# UNITED STATES PATENT AND TRADEMARK OFFICE

## Office Action Summary

10/648,387

CATER, MIRO S.

FIG.1

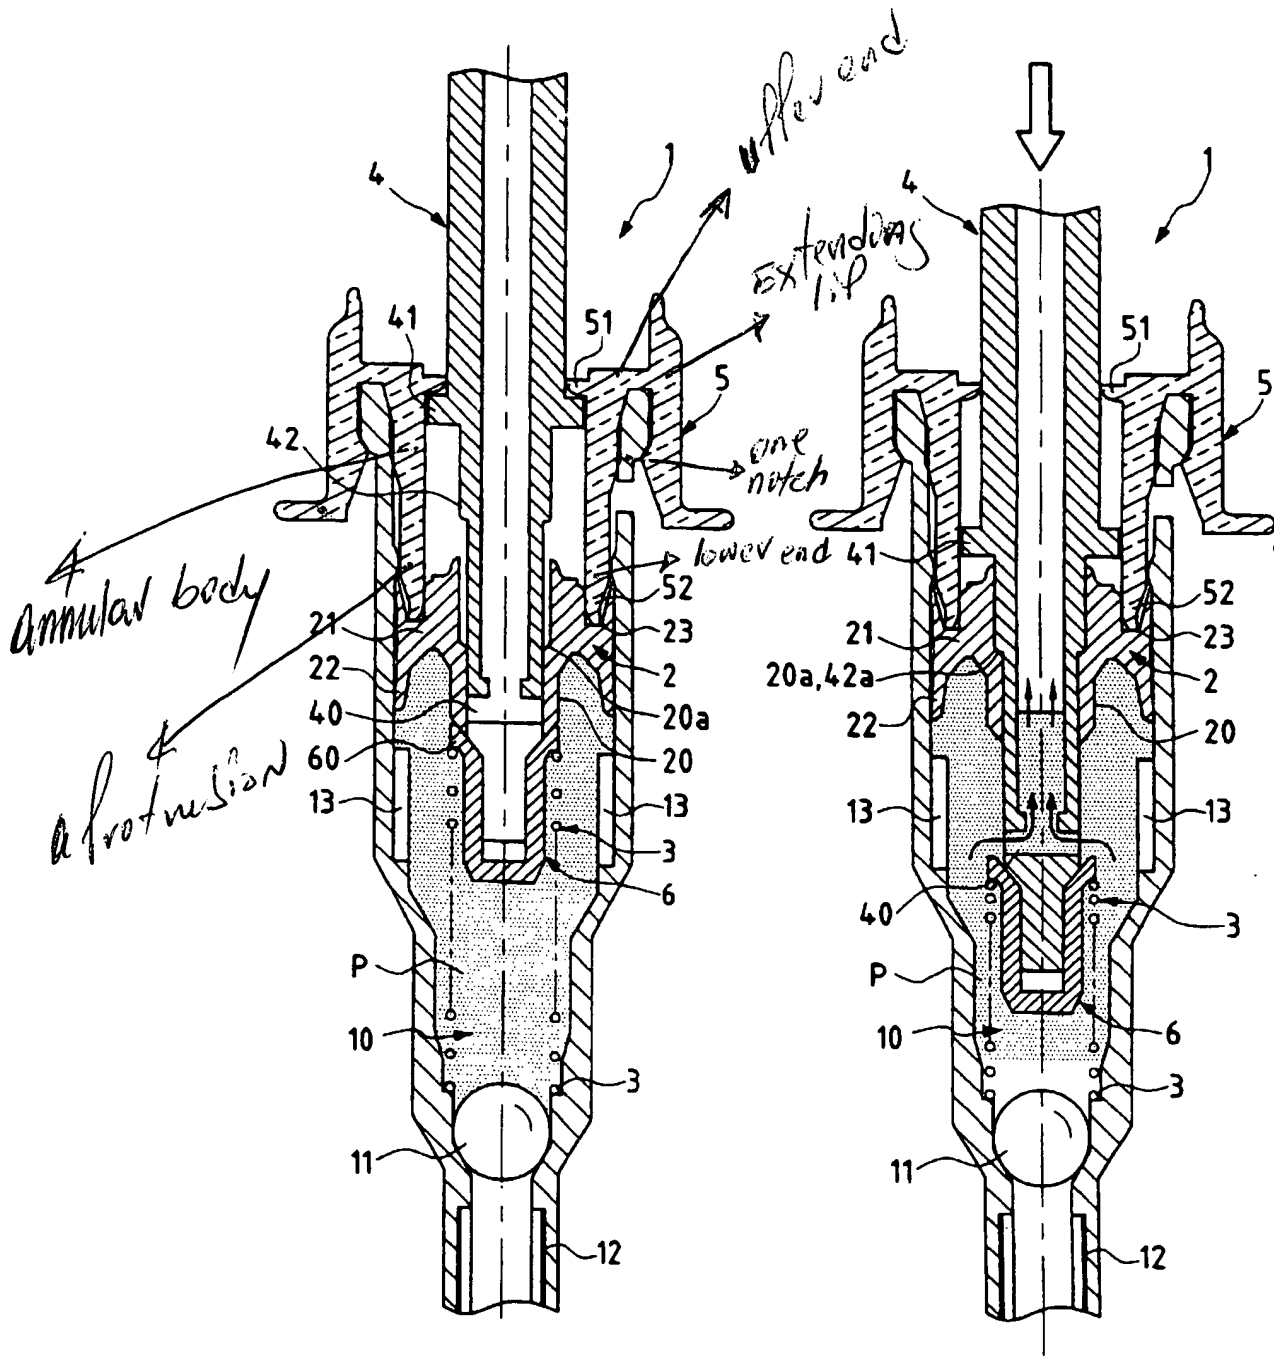
Bougament et al. disclose a housing cap (5) for securing a dispenser pump to a reservoir (col. 2, ll. 62-64), which comprises an annular body having an upper end and a lower end (see Figure 1 for the location of the annular body), the upper end having an outwardly extending lip (see Figure 1 for location), an outer surface of the lip adapted to sealingly engage a portion of the reservoir (col. 2, ll. 62-64), the lower end having a protrusion (see Figure 1 for location of the protrusion) for engaging the pump at a first location, the annular body defining at least one notch (see Figure 1 for the location of

one notch) for engaging the pump at a second location, the lip is defined by a helical area protruding from the annular body as seen in Figure 1, a seal (2).
